CITY of NOVI CITY COUNCIL

Agenda Item 3
September 14, 2015

SUBJECT: Approval of the request of Biltmore Land, LLC for development of Covington Estates, JSP 15-02 as a Residential Unit Development (RUD) and approval of the RUD Plan. The subject property is located on 48.83 acres in Section 31, north of Eight Mile Road and west of Garfield Road in the RA, Residential Acreage District. The applicant is proposing a 38 unit single-family development. The approval would be subject to entry into an RUD Agreement between the City and the applicant.

PLAN REVIEW CENTER REPORT

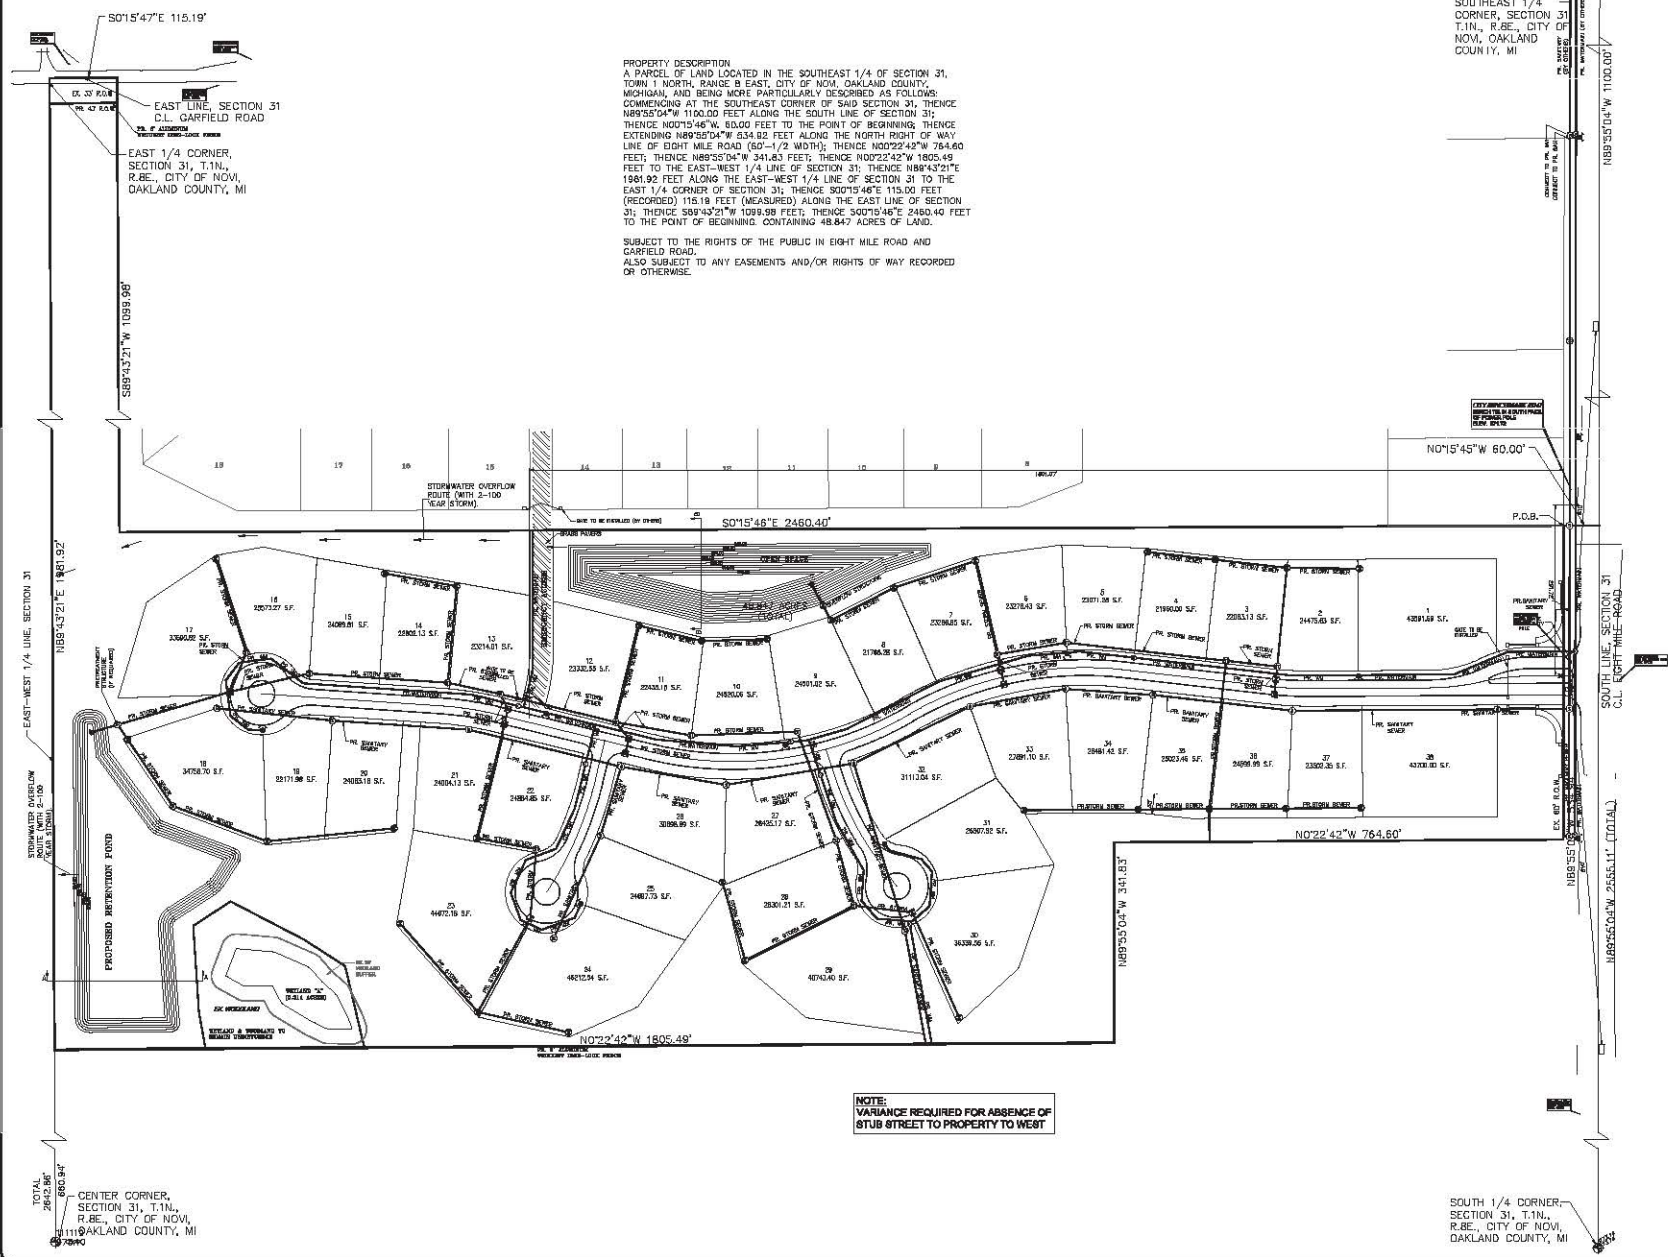
1. Provide the distance from 8 Mile to the emergency access. **If this distance exceeds 1500 feet a variance from Section 11-194 (a) (7) of the Novi City Code will be required.** This request must be submitted under a separate cover.

NOTE:
 VARIANCE REQUIRED FOR ABSENCE OF STUB STREET TO PROPERTY TO WEST

200 YEAR STORM DETENTION DESIGN (CITY OF NOVI DESIGN MANUAL)

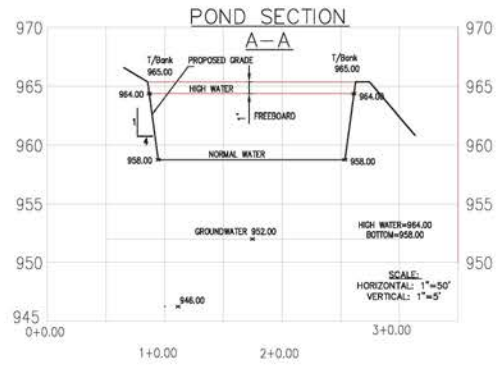
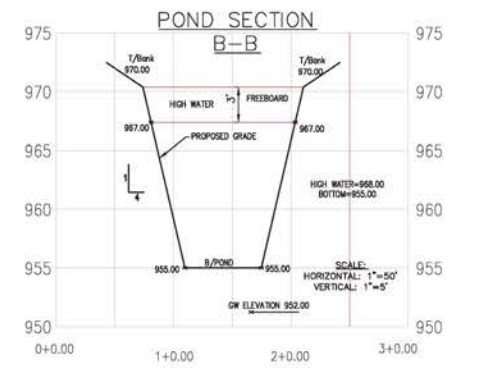
Approval of the Revised Concept Plan and the Preliminary Storm Water Management Plan is recommended.
